ADDENDUM F (NON-DSA APPROVAL)

PROJECT: Santa Ana College
Science Center

DATE: 8/31/2017

DSA File No.: 30-C2
DSA Applications No.: 04-115788
HGA Commission No.: 3584-001-00

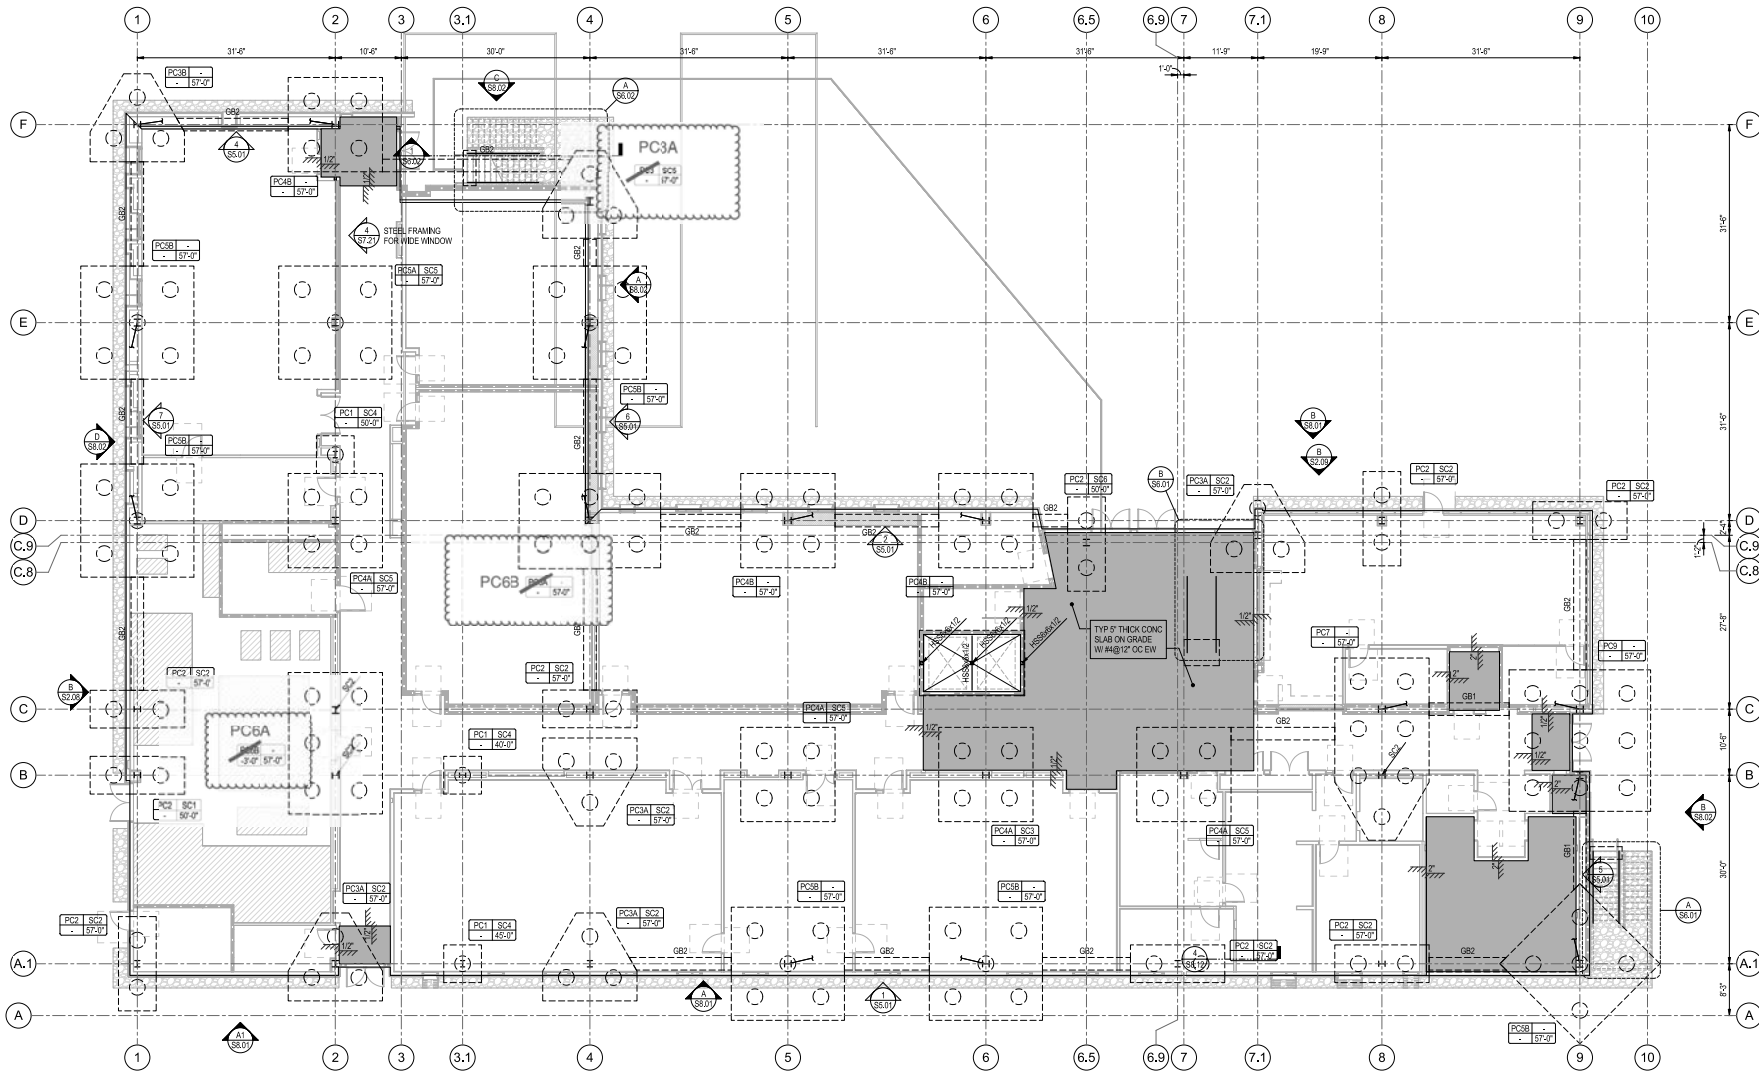
Detail 1/S3.02 there is a pile cap labeled PC6, however on the plans there is no PC6. Please confirm this pile cap should be PC6B in the schedule.

Please see attached mark ups to clarify the pile cap designations. Will be updated in the Addendum #2 drawings.

S2.01
DSA APPROVAL SET

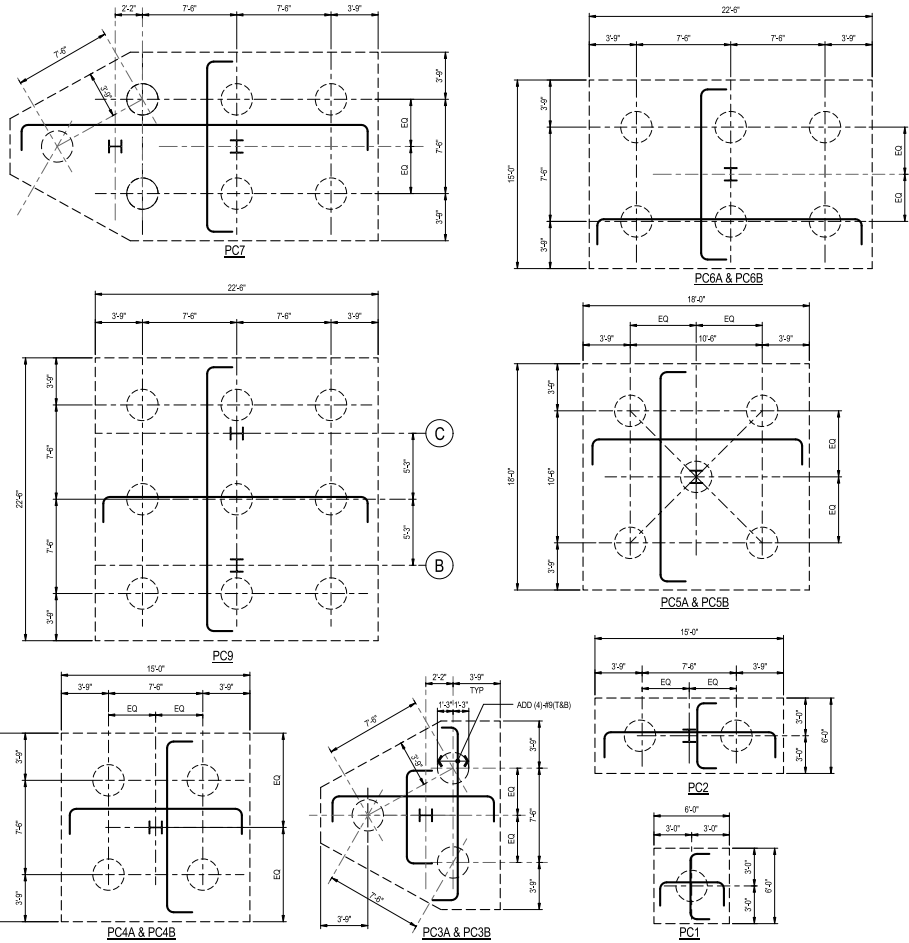
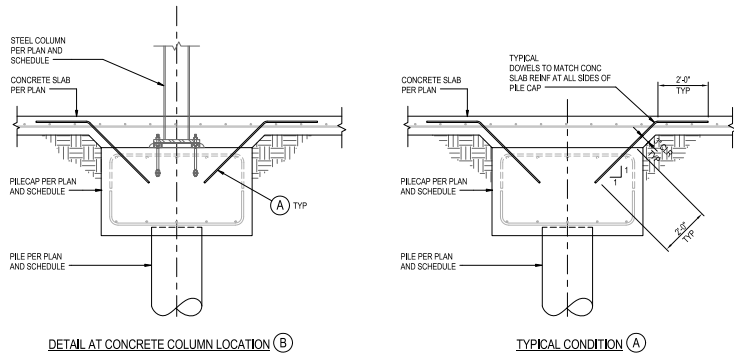
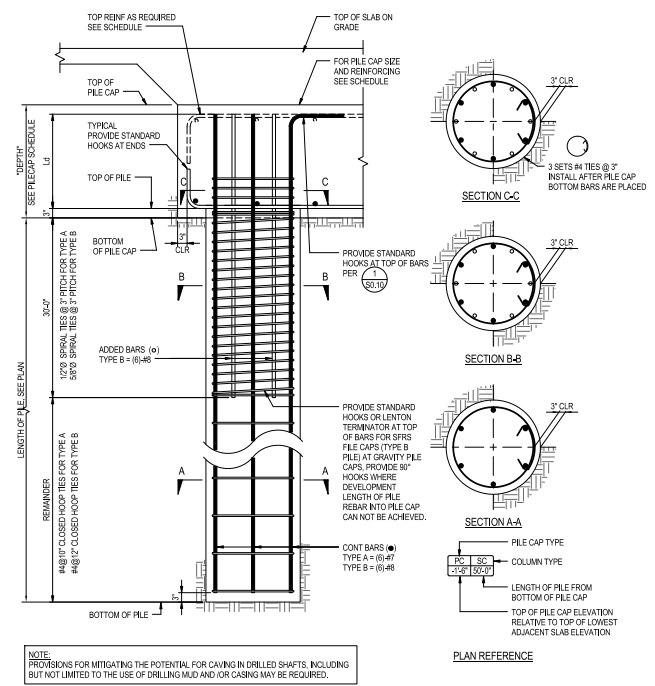
On sheet S2.01 at GL 4 between GL E & F the Pile cap is labeled as PC3, however on sheet S3.02 there is no PC3 in the schedule. Please advise if this should be labeled PC3A or PC3B?
